COVER LETTER

MODEL: L90D

TYPE: L19C0D060

REPORT NO.: HCT-F03-0409 HYUNDAI C-TECH 1/4

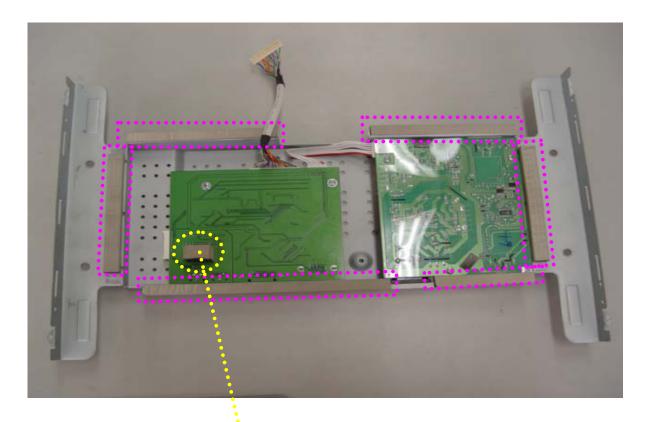
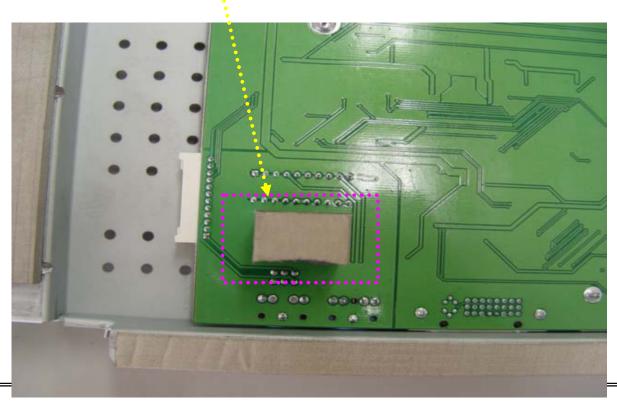
1.Attach a gasket on the Main Board and Main Frame to contact a LCD panel

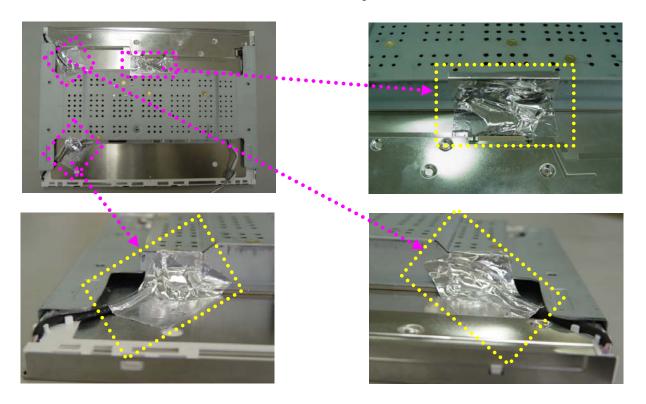
2. Attach a aluminum foil between Main Frame and LCD panel
